**John G. Haggard, Manager
Hudson River Program**

April 20, 2000

Re: Feasibility Study for Hudson River PCBs Superfund Site: Use of Models

Figure 1. Cohesive surface sediment PCB concentrations predicted under natural recovery by the EPA and GE models with an upstream source fixed at a concentration of 10 ng/L

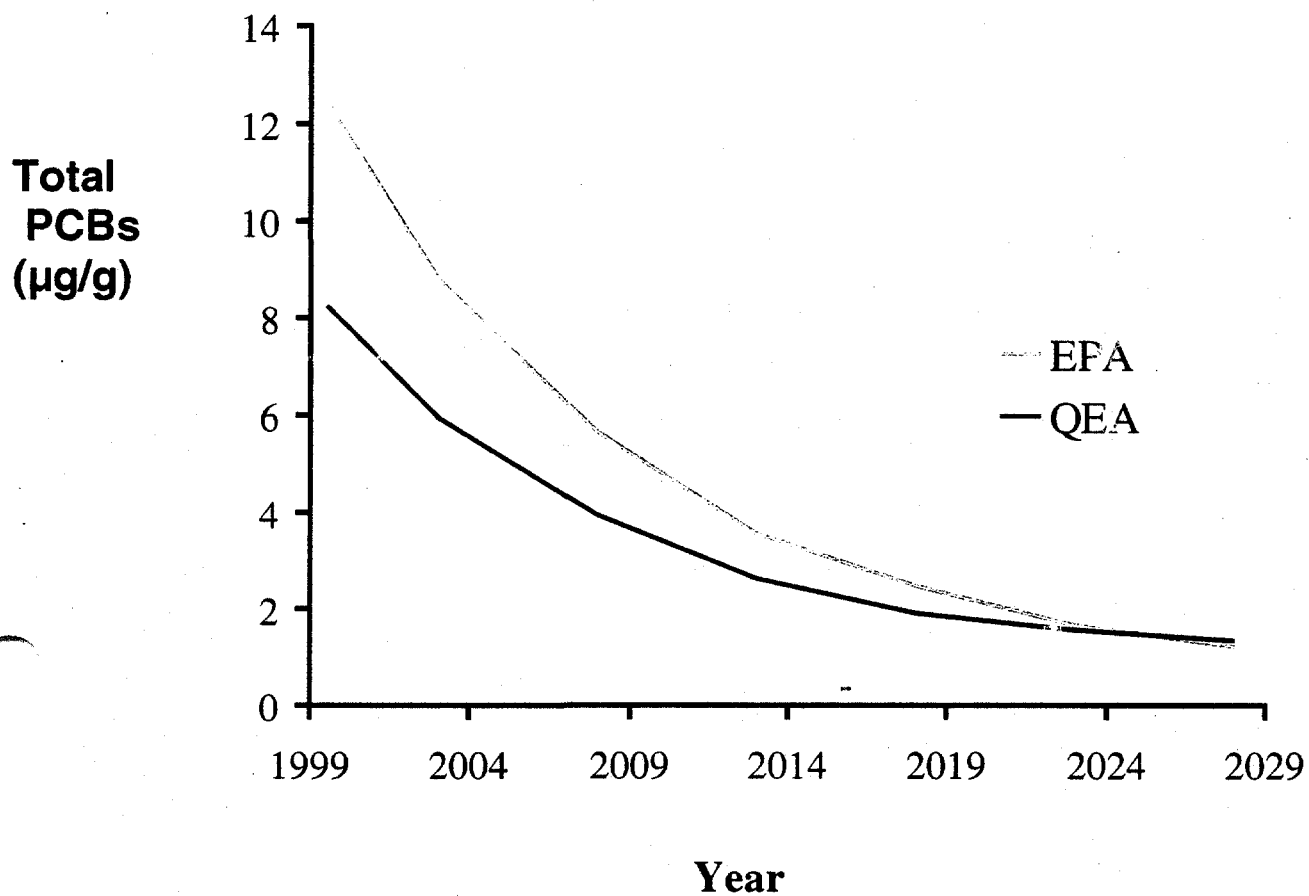
approximately 5-10 ppm. As demonstrated in Figure 1, natural recovery would achieve surface concentrations in this range before dredging could even begin. Further, the model results indicate that fish PCB levels would be near or below the FDA action limit by this time.

FIGURE 2. Sediment Volume Removed vs Time : Dredging Projects

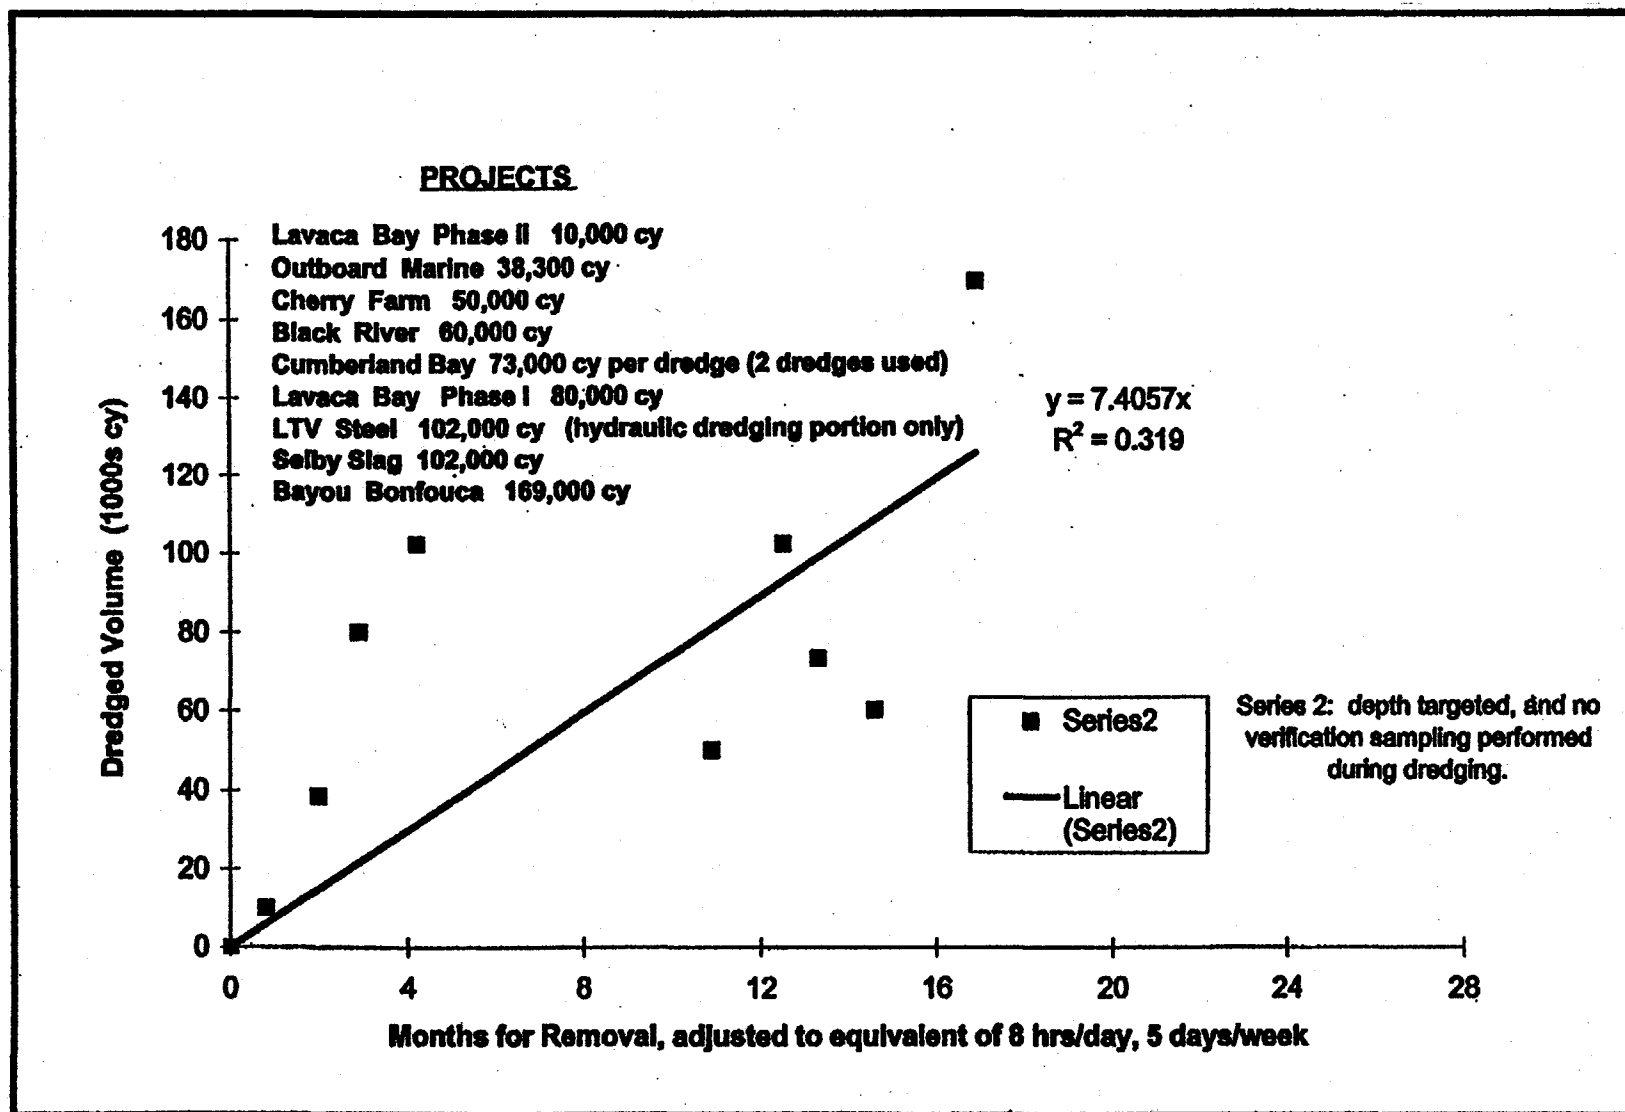
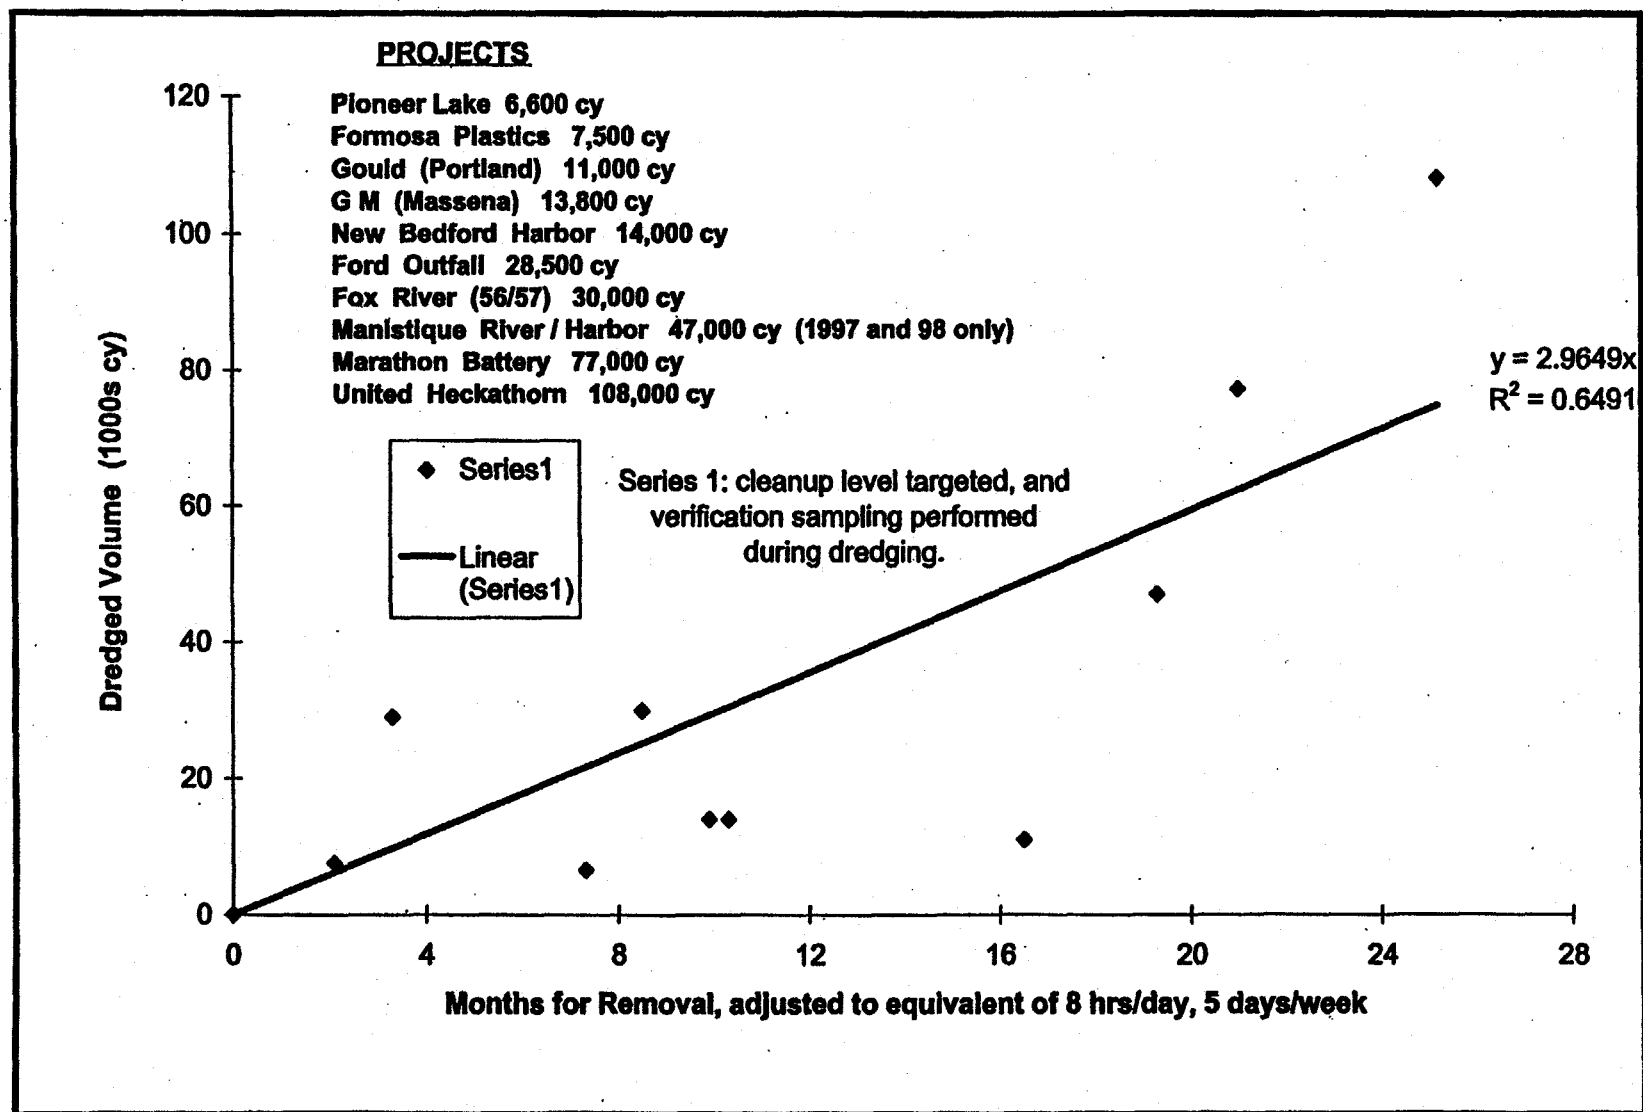
Figures 2 and 3 present total dredged volume vs. total dredging time for the 19 dredging projects. Dredge standby and operating time combined for each project has been adjusted to provide a common basis for comparison (*i.e.*, equivalent to a 40-hour week). For each graph, a straight line through the origin ($x = \text{months} = 0$; $y = \text{volume} = 0$) was then fit to these plotted points, the slope of which represents average monthly removal rate.

For the nine projects that targeted a depth only, the average monthly removal rate, adjusted to a 40-hour week, was in the range of 7,500 cubic yards per month. For the other ten projects, all of which targeted a cleanup level and included verification sampling, the average monthly removal rate, adjusted to a 40 hour week, was in the range of 3,000 cubic yards per month. Thus, experience from these other sites indicates that it is reasonable to assume a production rate of between 3,000 to 7,500 cy/month, depending on the nature of the project.

projects, EPA should consider the experience from other sites². EPA should use a range of these rates to determine the sensitivity of the results to the amount of time a dredging project would take to complete. We believe that regardless of the rate assumed, EPA will conclude as we have that remedial dredging will not achieve a faster recovery than is naturally occurring.

Figure 4. Pre- and Post Dredging Sediment PCB Concentrations

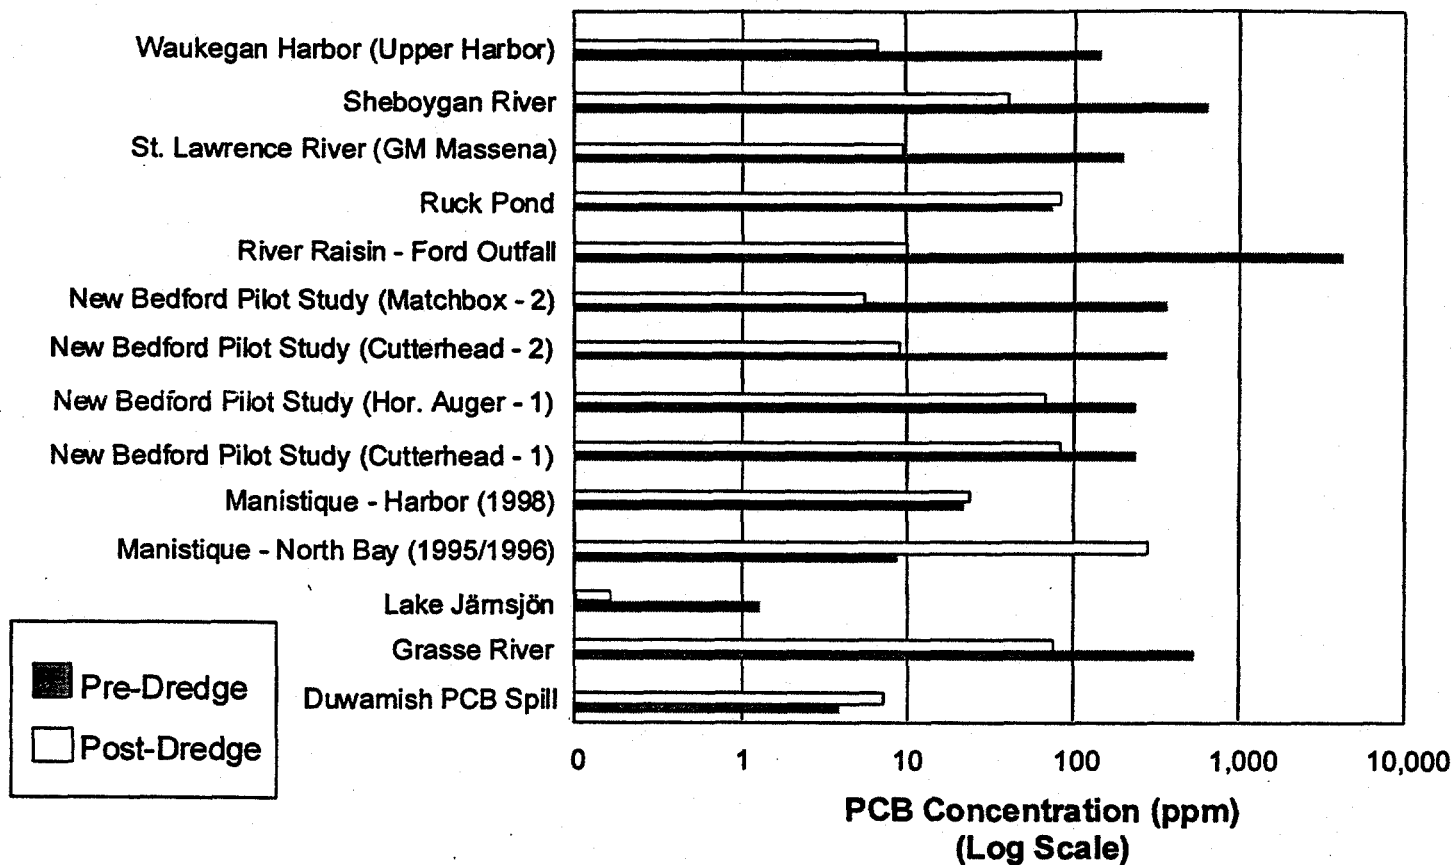
This conclusion is supported by available data from other sites. Figure 4 summarizes PCB sediment data from several completed dredging projects. Sediment removal projects at Grasse River, Ruck Pond, and Sheboygan River left sediment with PCB concentrations on the order of 50-75 ppm. Moreover, the data show that it is not feasible to achieve significant reductions when pre-dredging surface concentrations levels. At, Lake Järnsjön, the initial surface concentration was 1.5 ppm; dredging was only able to lower these levels to 1 ppm. When reviewed as a whole, the results show that the best dredging could accomplish was surface sediment PCB concentrations of
